# PCN-20210219 TE0745-02 DDR3 Change and Product Update

<b>Company</b>	Trenz Electronic GmbH
<b>PCN Number</b>	PCN-20210219
<b>Title</b>	TE0745-02 DDR3 Change and Product Update
<b>Subject</b>	BOM change
<b>Issue Date</b>	2021-03-09

This change affects all Trenz Electronic TE0745 SoMs of revision 02: TE0745-02-\*

## #4 Set S/N to not fitted

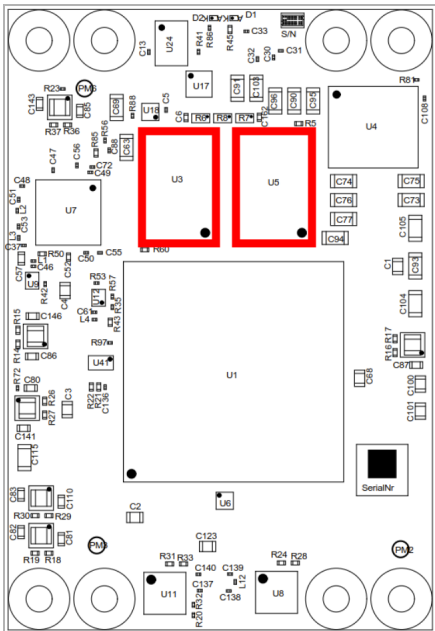
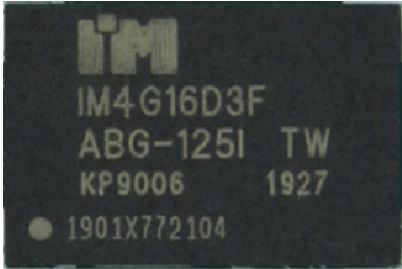
**Reason:** Part is end of life.

**Impact:** Track it pad no more available. Pin 20 of CPLD was connected via S/N to GND and is now floating. However pin is not used in delivery CPLD Firmware, so no further impact.
